Application No.	Applicant(s)				
Office Action Comments	10/776,176	COUTURE, MICHEL				
Office Action Summary	Examiner	Art Unit				
	Mark Hageman	3653				
The MAILING DATE of this communication appears on the cover sheet with the correspondence address Period for Reply						
A SHORTENED STATUTORY PERIOD FOR REPLY IS SET TO EXPIRE 3 MONTH(S) OR THIRTY (30) DAYS, WHICHEVER IS LONGER, FROM THE MAILING DATE OF THIS COMMUNICATION. - Extensions of time may be available under the provisions of 37 CFR 1.136(a). In no event, however, may a reply be timely filed after SIX (6) MONTHS from the mailing date of this communication. - If NO period for reply is specified above, the maximum statutory period will apply and will expire SIX (6) MONTHS from the mailing date of this communication. - Failure to reply within the set or extended period for reply will, by statute, cause the application to become ABANDONED (35 U.S.C. § 133). Any reply received by the Office later than three months after the mailing date of this communication, even if timely filed, may reduce any earned patent term adjustment. See 37 CFR 1.704(b).

DETAILED ACTION

Fig 11

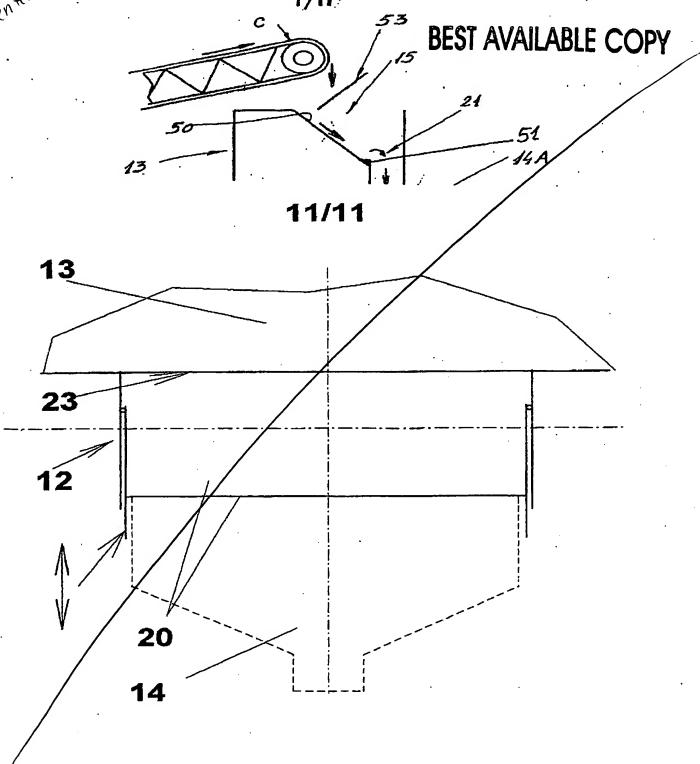
2. The drawing amendment filed 3-2-2006 has not been entered as it introduces new matter. Specifically figure 11 adds structure not supported by the original specification.
